Subject: Virgil C. Summer Nuclear Station (VCSNS) Units 2 and 3 Combined License Application (COLA) - Docket Numbers 52-027 and 52-028 Response to NRC Request for Additional Information (RAI) Letter No. 030

**NRC RAI Letter No. 030 Dated February 10, 2009**

**SRP Section: 2.5.2 – Vibratory Ground Motion**

**Figure RAI-12A.** Peak ground acceleration hazard curves for a site in southern California illustrating sensitivity to aleatory standard deviation (log 10 units). Reproduction of Figure 2-10 of Abrahamson and Bommer (2006).

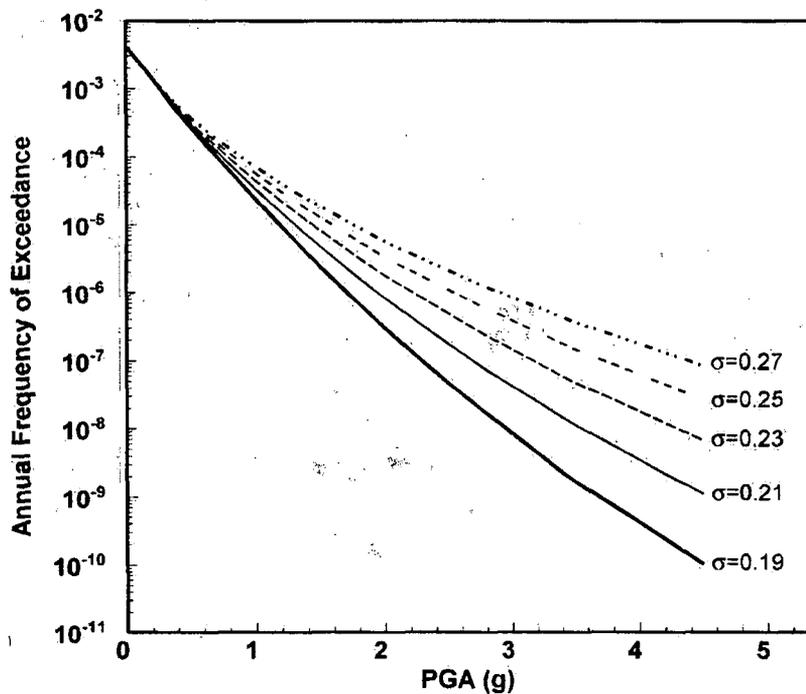
FSAR Section 2.5.2.4.5 (page 2.5.2-40) states that the applicant used the results of Abrahamson and Bommer (2006) to characterize aleatory uncertainties. Please discuss the effect of using the Abrahamson and Bommer (2006) uncertainties on the calculated hazard, as well as the differences between Abrahamson and Bommer (2006) and the EPRI (2004) study. Please also explain how the seismic hazard curves and the UHRS would change if the EPRI (2004) aleatory uncertainties had been used rather than those in Abrahamson and Bommer (2006).

Lower aleatory uncertainties in the ground motion equations will result in lower seismic hazard curves. For example, Figure RAI-12A (a reproduction of Figure 2-10 from Abrahamson and Bommer, 2006) shows peak ground acceleration seismic hazard curves for a site in southern California with a range of aleatory uncertainties in the ground motion equation. If the EPRI (2004) aleatory uncertainties had been used in the VCSNS seismic hazard analysis, the seismic hazard curves and UHRS for the Summer site would have been higher.

**Figure RAI-13A.** Ground motion model clusters, individual models, and weights recommended for general area sources (reproduced from Figure 5-2 of EPRI, 2004).

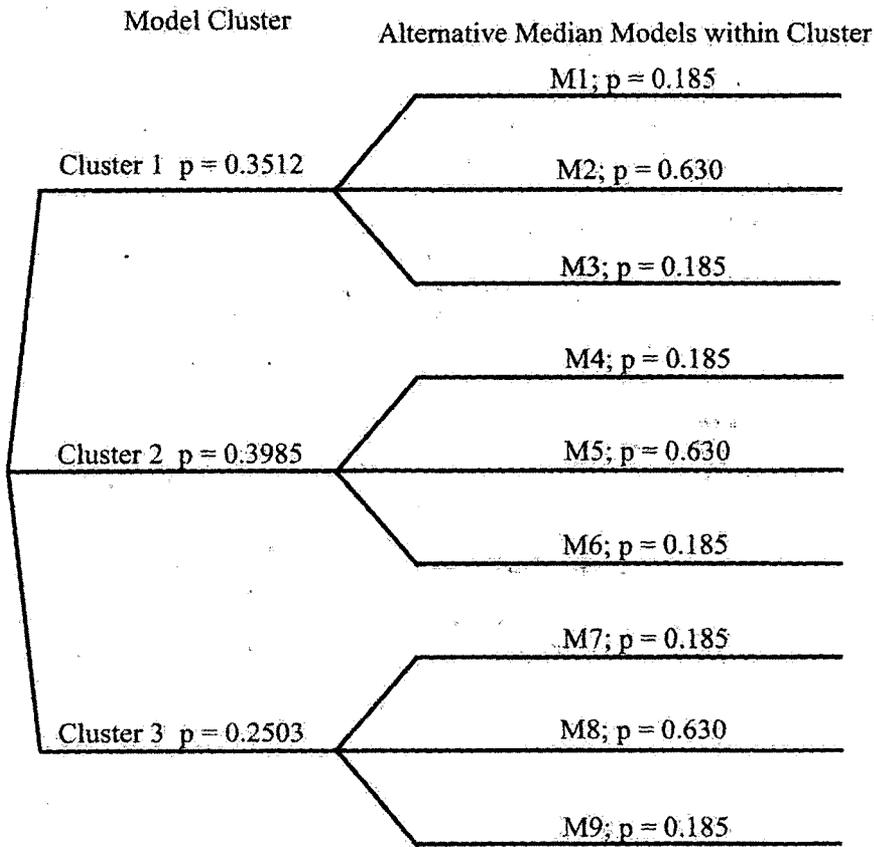
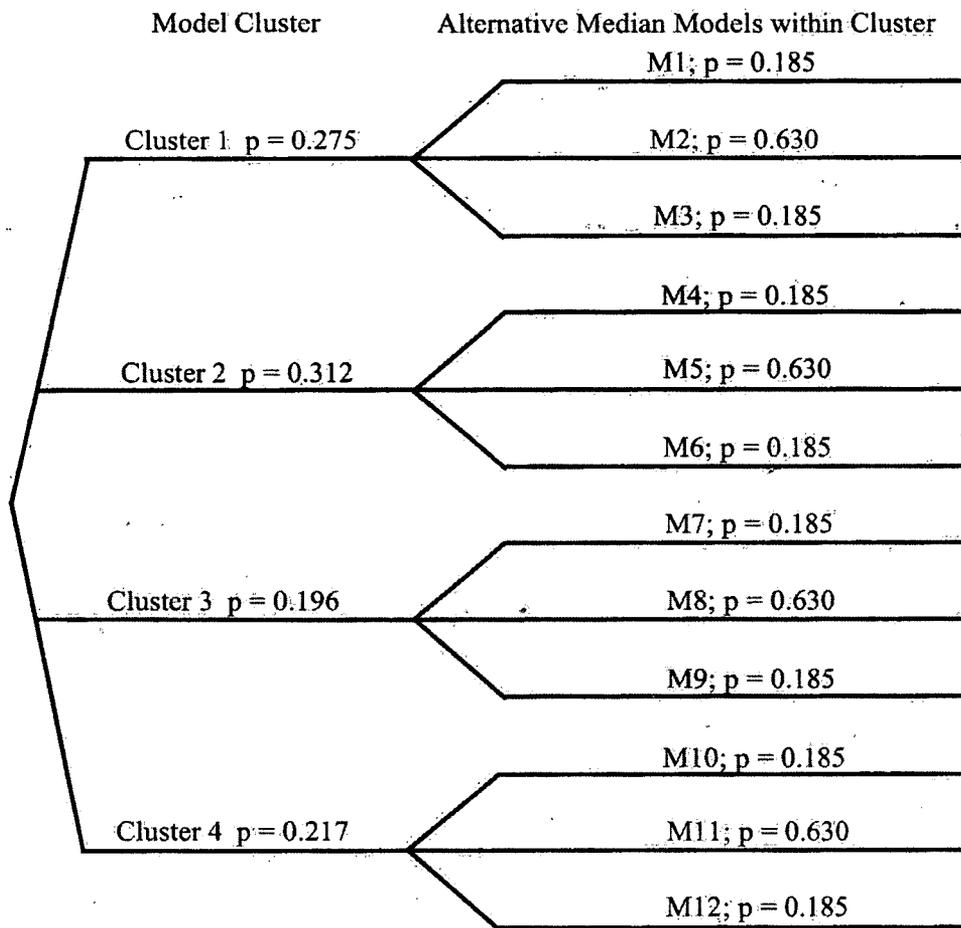
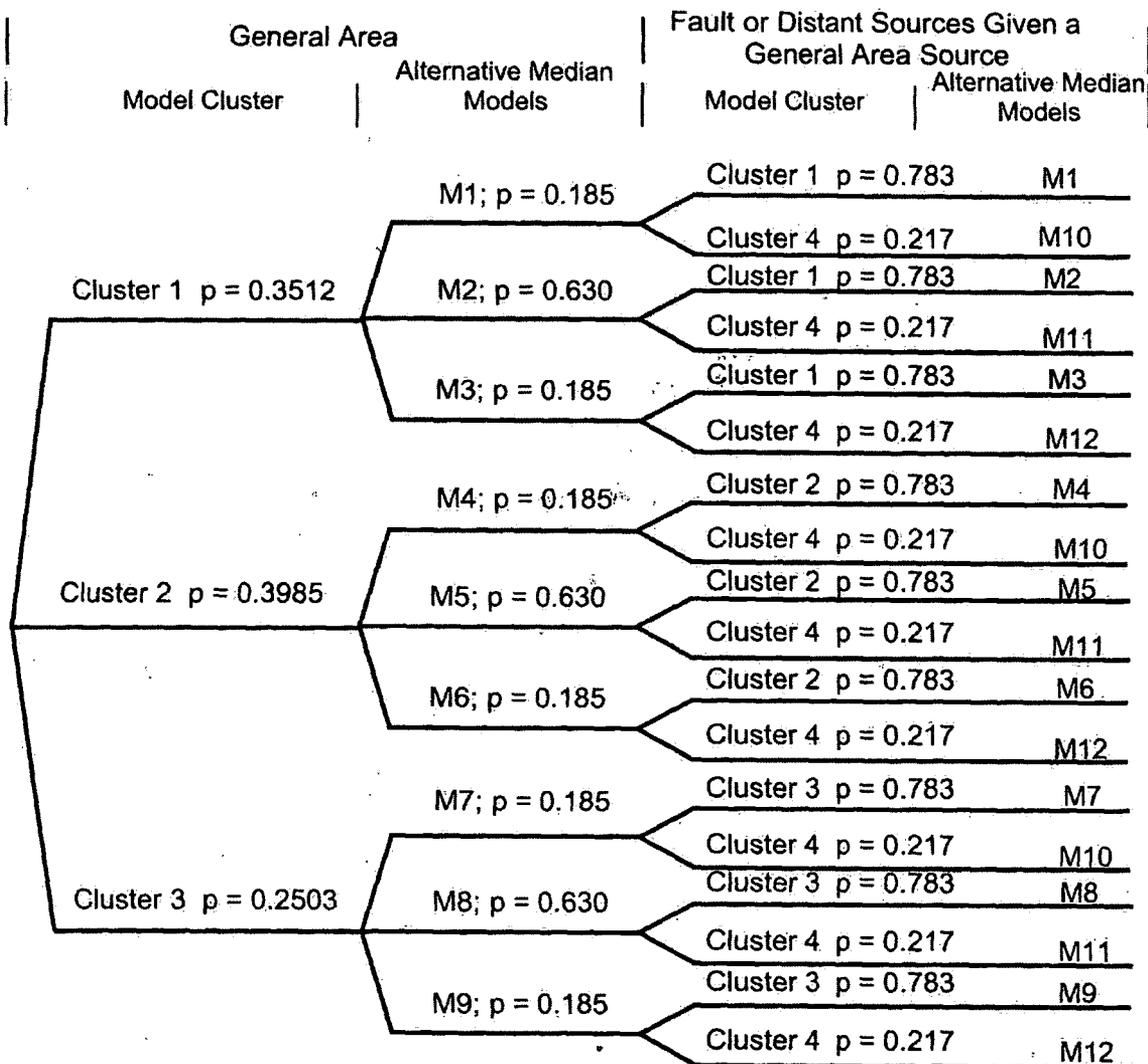
In FSAR Section 2.5.2.4.5 (page 2.5.2-40), the applicant stated that it used the EPRI (2004) ground motion equations in its updated PSHA. However, the EPRI ground motion report contains many equations that are arranged in “clusters.” Please provide more detail regarding how the applicant used the various equations from the EPRI ground motion report to compute the site hazard, including the weights that the applicant applied for the specific equations, if multiple equations were used in the analysis.

The EPRI (2004) ground motion equations consist of four clusters, each of which has a high, medium, and low estimate. Figure RAI-13A shows that for general area sources, only the first 3 clusters are used in the analysis. Figure RAI-13A indicates the weights on the nine equations used for general area sources. For non-general sources, Figure RAI-13B shows that all four clusters are used in the analysis, and Figure RAI-13B indicates the weights on the 12 equations used for non-general sources. When both general area sources and non-general sources are used in a hazard analysis, the nine equations shown in Figure RAI-13A and the 12 equations shown in Figure RAI-13B are used in a specific set of combinations, and these combinations (and their weights) are shown in Figure RAI-13C. Thus both the number of equations and their weights depend on the specific types of sources that are used for a seismic hazard analysis. The seismic hazard analysis for the Summer site used the weights given in EPRI (2004) for all clusters and all equations within a cluster.

**Figure RAI-14A.** 1 Hz spectral accelerations predicted for M=7 for the EPRI (2004) models and for the Atkinson and Boore (2006) and Tavakoli and Pezeshk (2005) references.

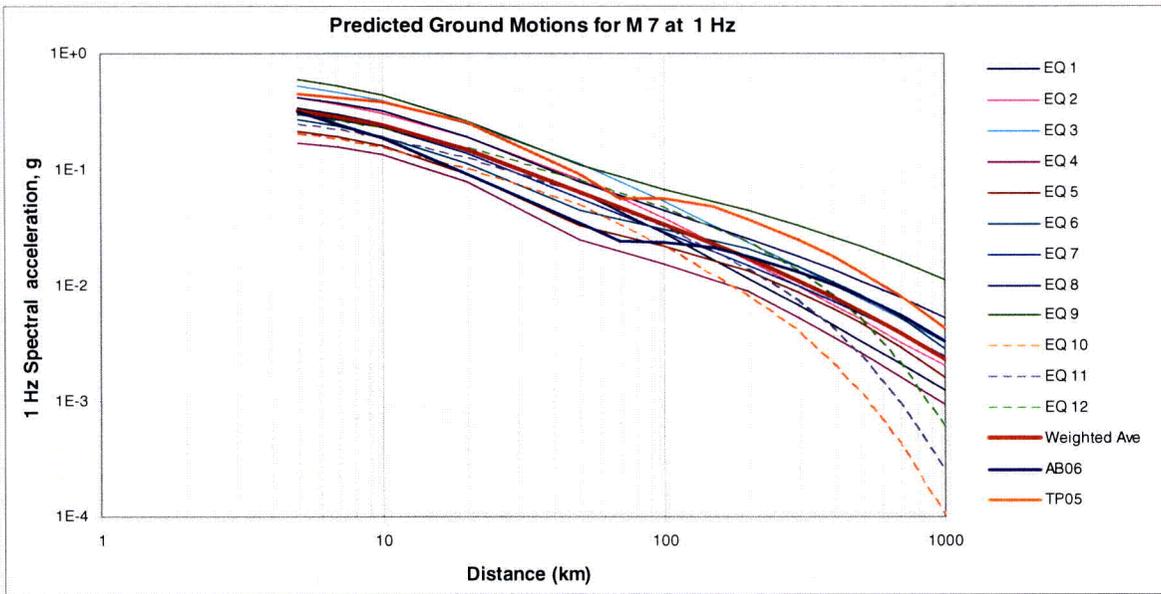
NUREG-0800 states that use of the EPRI ground motion models (2004) “is acceptable as long as an adequate investigation has been carried out to provide reasonable assurance that there are no significant updates or new models that may impact on the results of the PSHA.” Section 2.5.2.4.5 of the FSAR does not discuss any new ground motion models. However, at least two new ground motion prediction models for the CEUS have been published in peer-reviewed literature since 2004: (1) “Empirical-stochastic ground-motion prediction for eastern North America” by Tavakoli and Pezeshk (Bulletin of the Seismological Society of America, 2005, v.95[6], 2,283-2,296) and (2) “Earthquake ground-motion prediction equations for eastern North America” by Atkinson and Boore (Bulletin of the Seismological Society of America, 2006, v.96[6], 2,181-2,205). In addition to these specific models, the latest version of the US National Seismic Hazard maps (Petersen and others, 2008) computes ground motions from a weighted combination of a number of ground-motion prediction equations. As such, these ground motions can be considered another ground-motion model. Please provide justification for not considering these new ground-motion prediction models.

Figure RAI-14A plots ground motion amplitudes for 1 Hz spectral acceleration for  $M=7$  earthquakes vs distance for the 12 equations used from EPRI (2004), and for the Tavakoli and Pezishk (2005) and Atkinson and Boore (2006) references. At all distances, the range of the 12 EPRI (2004) models encompasses the ground motions predicted by the other two references.
